Freightliner
Service Bulletin

Description of Revisions: *This bulletin replaces the version dated November 2014. Part numbers have been added.*

Fig. 1, S-Cam Support Bracket 11-15990-001

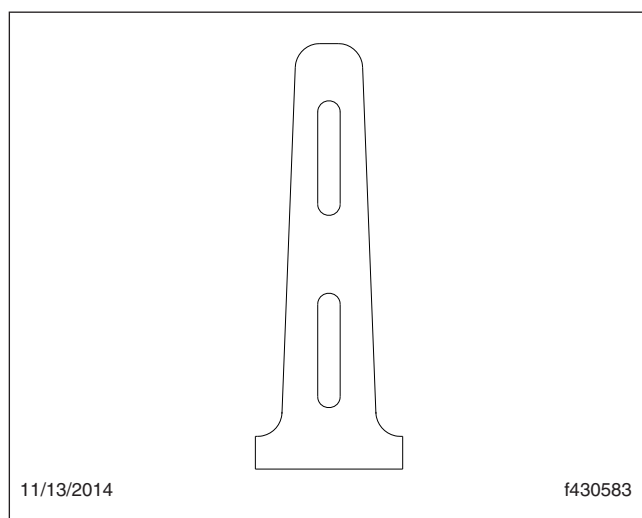
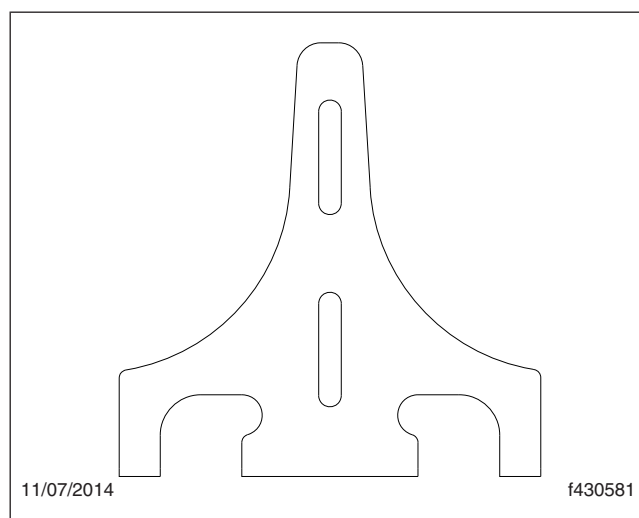
Some production rear axle s-cam support brackets (11-15990-001) on Cascadia trucks may crack under certain operating conditions. A more robust rear axle s-cam support bracket (11-29558-001) is available if needed. See [Fig. 1](#) for an example of 11-15990-001, and [Fig. 2](#) for an example of 11-29558-001. Either part is acceptable for replacement of a cracked bracket. Use the instructions below to replace the support bracket.
